CASE CAPTION: Discuss and consider a request by Lisa Deaton of Palm Development Partners, LLC on behalf of Donna Perry of East Shore J/V for the approval of a Site Plan for a Medical Office Building on a 1.4384-acre parcel of land identified as Lot 27, Block A, The Standard-Rockwall Addition, City of Rockwall, Rockwall County, Texas, zoned Planned Development District 68 (PD-68) for Commercial (C) District land uses, situated within the SH-205 Overlay (SH-205 OV) District, addressed as 1301 S. Goliad Street [SH-205], and take any action necessary.

DEPARTMENT	REVIEWER	DATE OF REVIEW	STATUS OF PROJECT
PLANNING	Ryan Miller	10/24/2025	Approved w/ Comments

10/24/2025: SP2025-041; Site Plan for a Medical Office Building at 1301 S. Goliad Street  
Please address the following comments (M= Mandatory Comments; I = Informational Comments)

CASE NO.  
Z2025-055  
SHEET NO.  
L-1

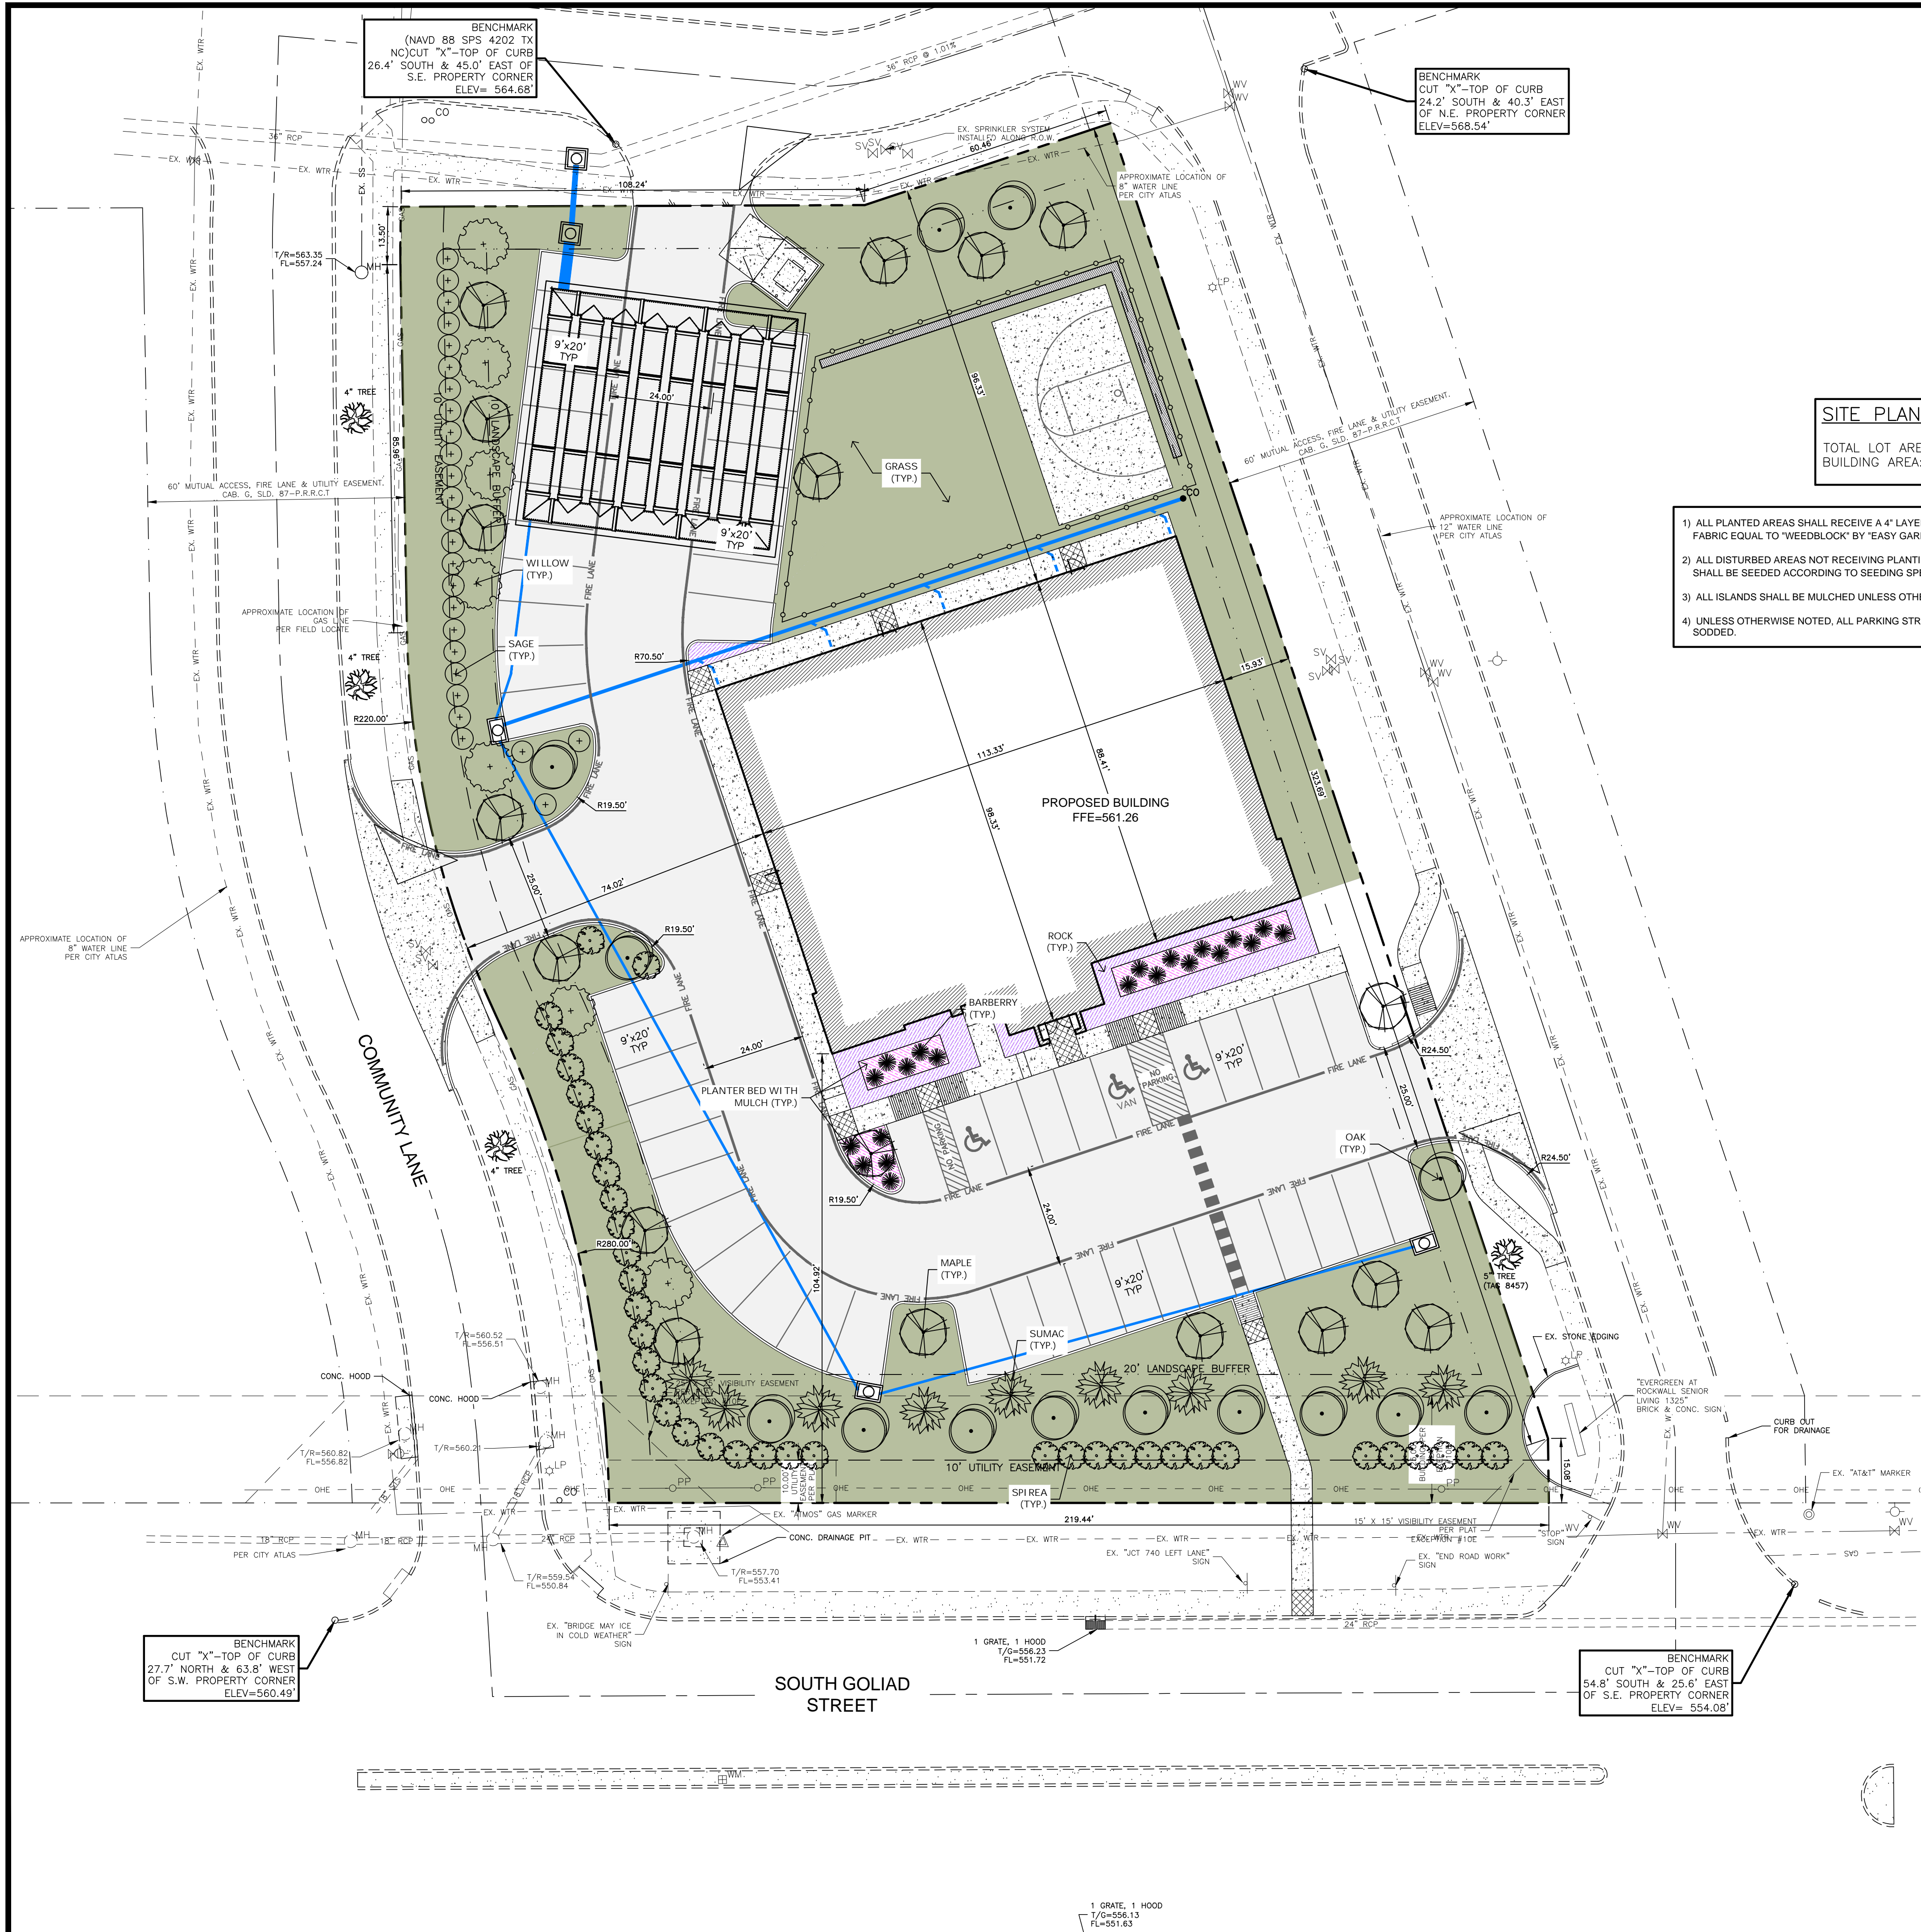
#### M.8 Landscape Plan.

- (1) Provide the same site data information required in Section 2.1 Site Plan: Miscellaneous and Density and Dimensional Requirements of this checklist. (See Sec. 2.1 of the checklist)

- (2) Please provide three (3) tiered landscape screening along the northeast property line. (Subsection 05.02.B, of Article 08, UDC)
- (3) Please provide one (1) canopy tree and one (1) accent tree per 50-linear feet along the east access easement. This can serve as a compensatory measure. (Subsection 05.05, of Article 08, UDC)

- (4) All pad mounted equipment must be shown; this includes franchise utilities. This equipment must be screened with five (5) gallon evergreen shrubs, which should be shown on the landscape plan. (Subsection 01.05.C, of Article 05, UDC)

- (5) All shrubs shall be five (5) gallon. (Subsection 05.05. B, of Article 08, UDC)
- (6) All parking spaces that face onto a roadway must have a row of 5-gallon evergreen shrubs planted in front of them for headlight screening. (Subsection 05.03, of Article 08, UDC)

**1 SITE PHOTOMETRIC PLAN**  
SCALE: 1" = 20'-0"

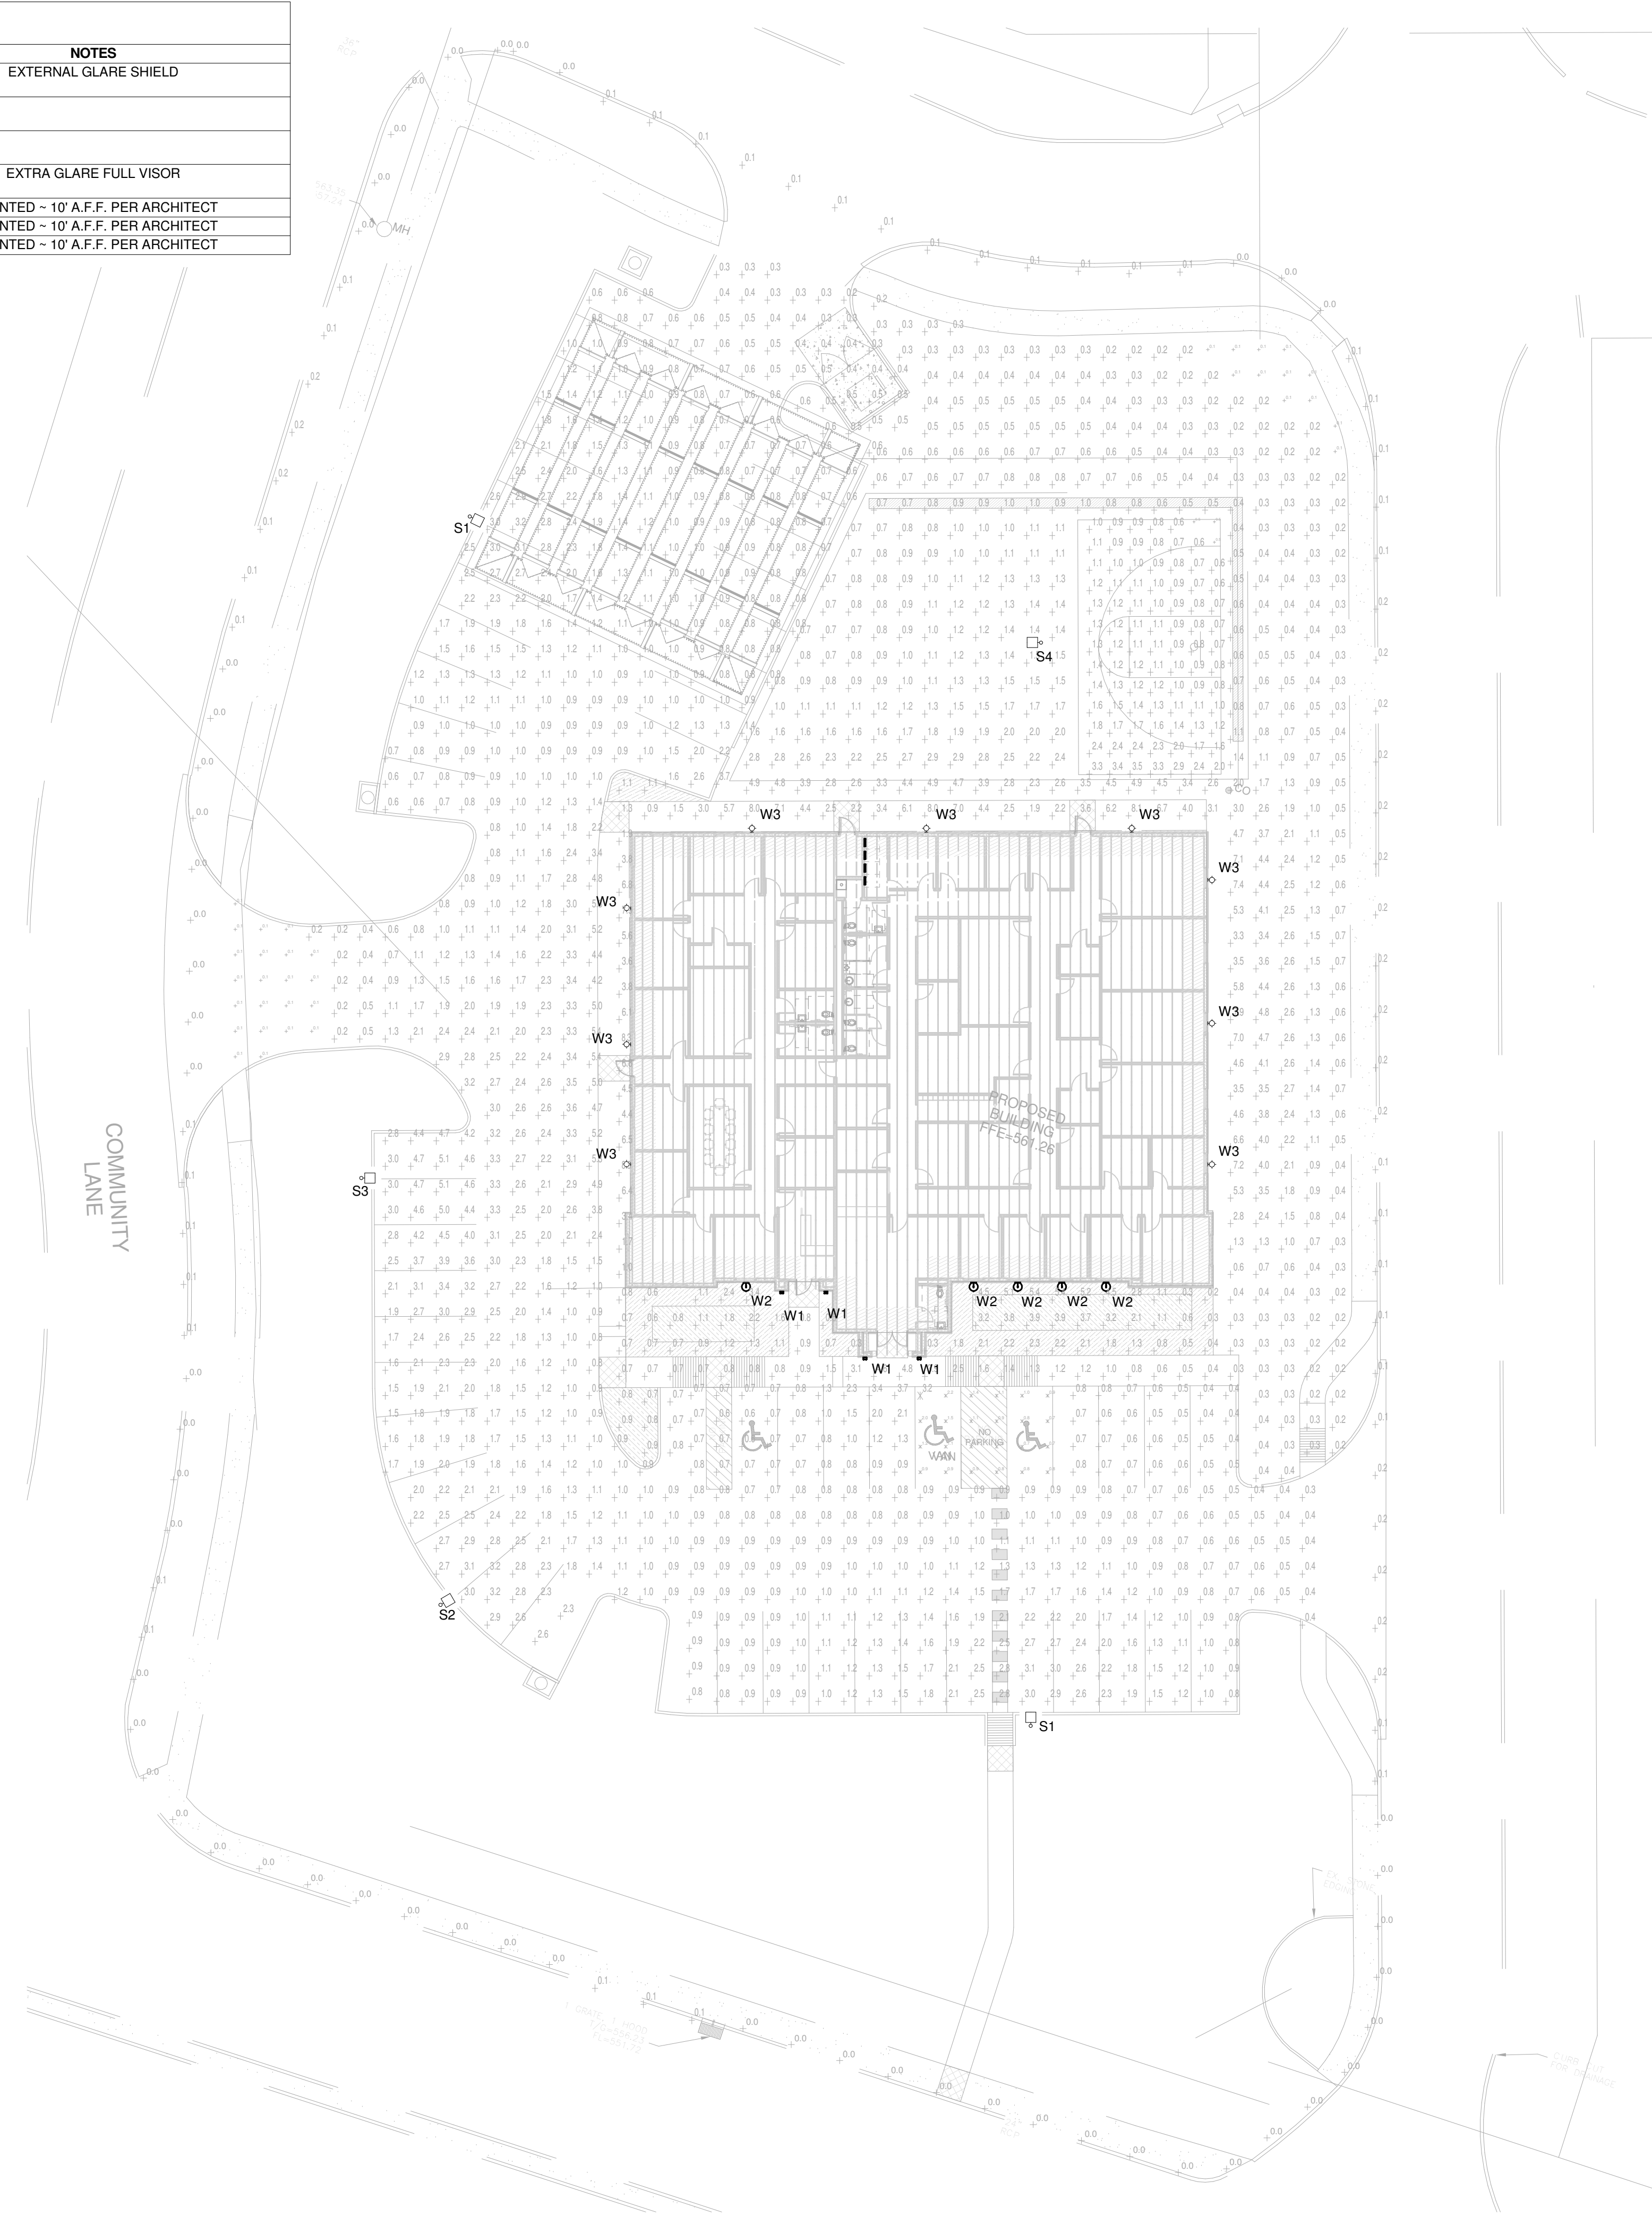
#### M.10 Photometric Plan

- (1) Provide the same site data information required in Section 2.1 Site Plan: Miscellaneous and Density and Dimensional Requirements of this checklist. (See Sec. 2.1 of the checklist)
- (2) Light levels shall not be greater than 0.2 FC at all property lines. In addition, the light levels should be 0.0 FC adjacent to S. Goliad Street, and the northeast property line. In this case, the light levels appear to be taken from the edge of pavement and not the property line. Please correct the photometric plan to address this requirement. (Subsection 03.03, of Article 07, UDC)
- (3) Please indicate the mounting height for all of the fixtures. All fixtures may not be mounted greater than 20-feet. (Subsection 03.03, of Article 07, UDC)
